Lightweight Steel Framing Design Manual, 2nd Edition
Canadian Sheet Steel Building Institute

Errata #1 – May 23, 2006

Errata #2 – May 14, 2007

FIGURE 3-2

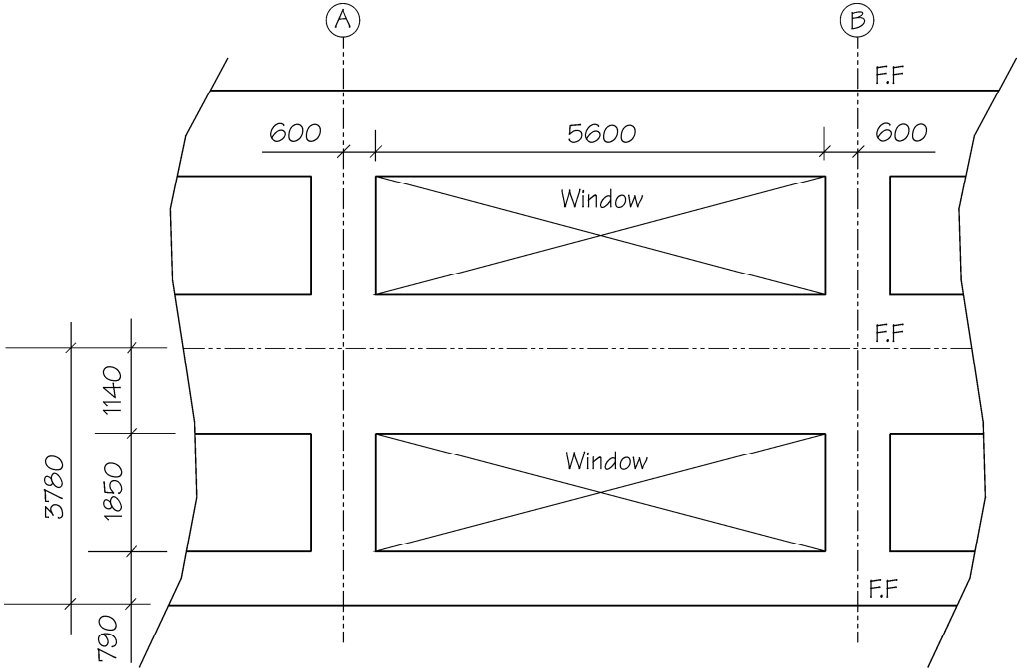
3. On page 3-3 top, add Figure 3-2 (see below)
